Appl. No. 10/827,057
Amendment dated January 26, 2006
Reply to Office Action of October 27, 2005

AMENDMENTS TO THE DRAWINGS

FIG. 1

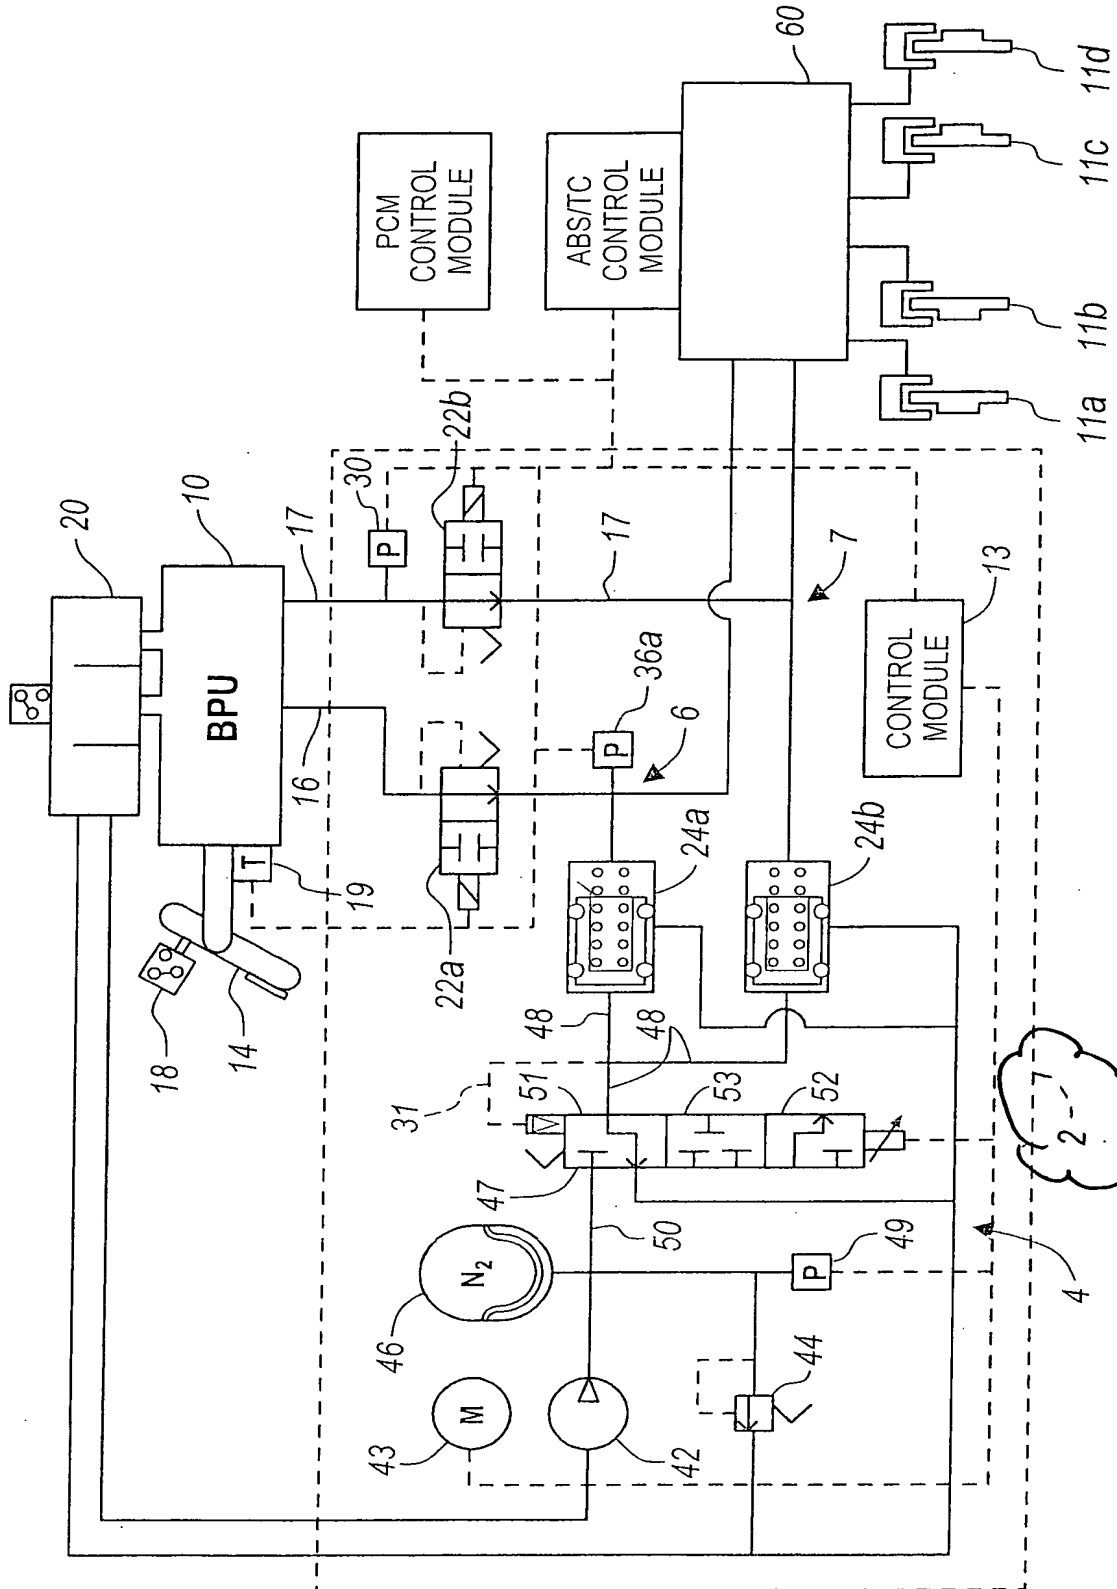
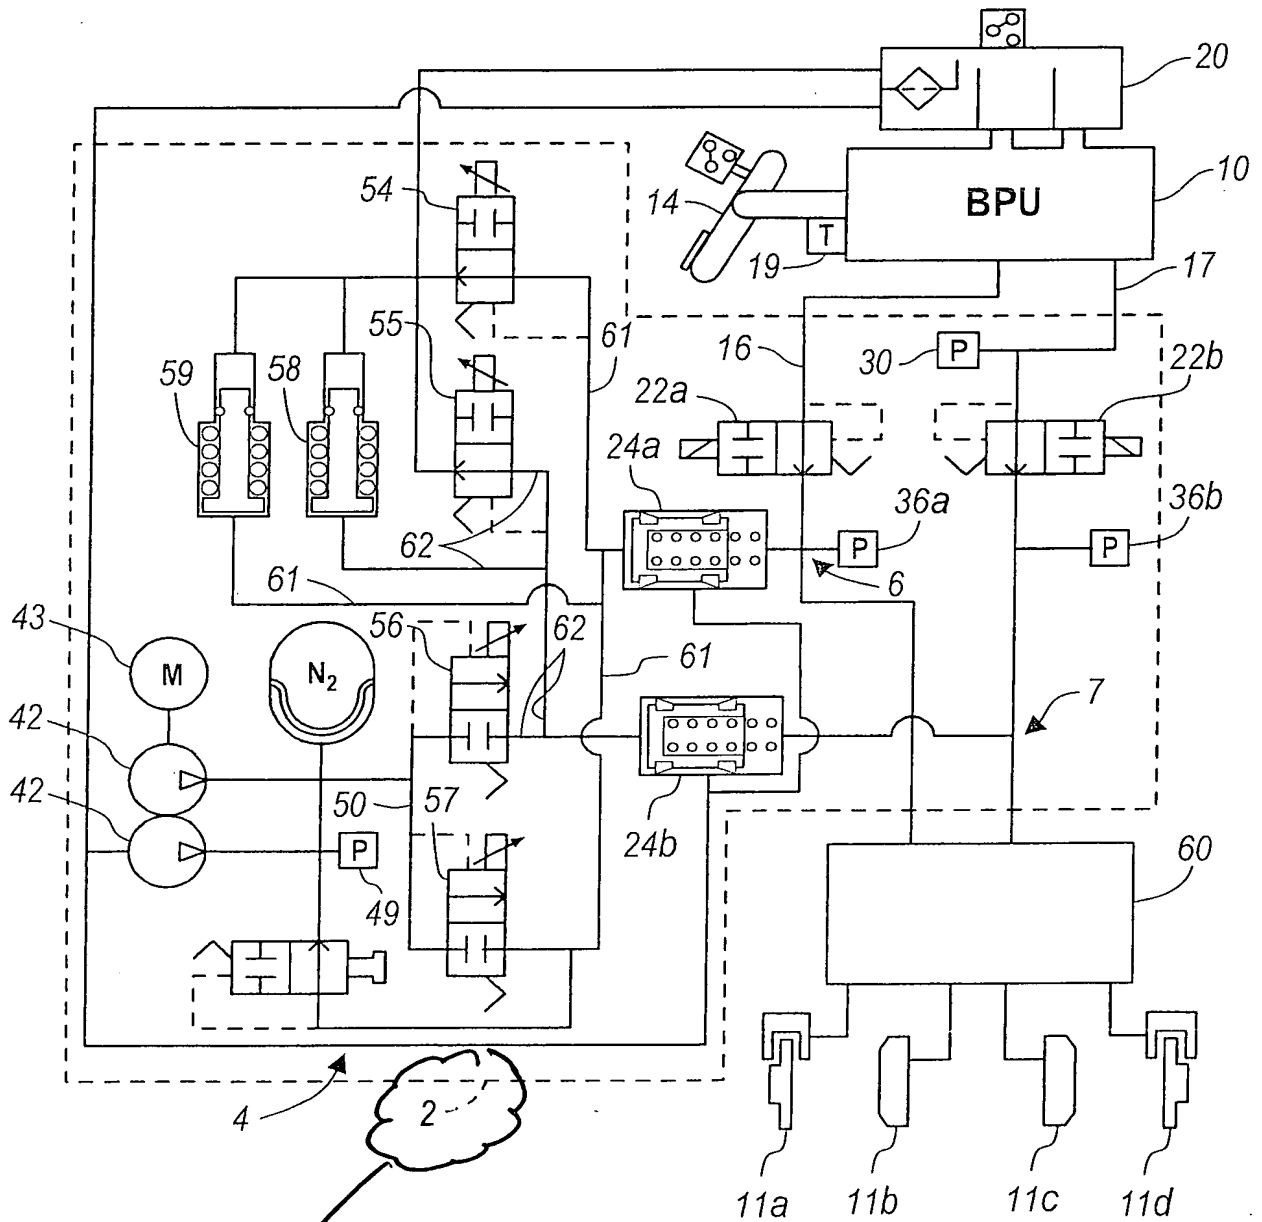
The attached sheets of drawings include amendments to Figs. 1 through 4, and 6 through 9; in each case the amendment is to add the previously omitted reference number 2. The accompanying replacement drawings replace all of the original sheets of drawings.

Replacement drawings are enclosed as an attachment. The drawings contain amendments to add reference number 2 to Figs. 1-4, and 6-9. Reference number 2 is referred to in the text, for example on page 4, line 11, to refer to a "vehicle brake module".

FIG. 7

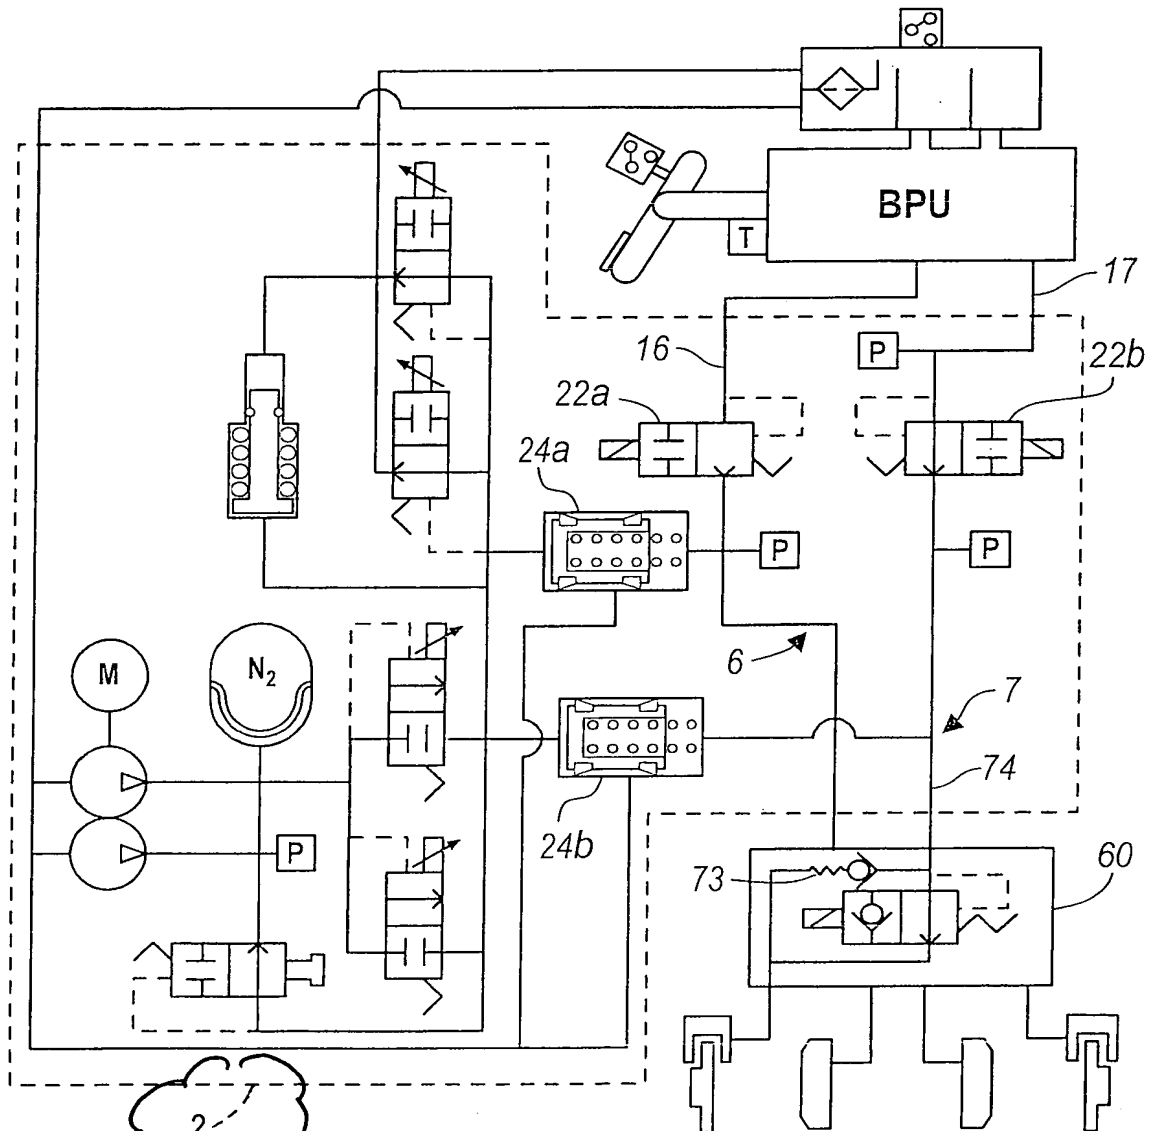
2
 added
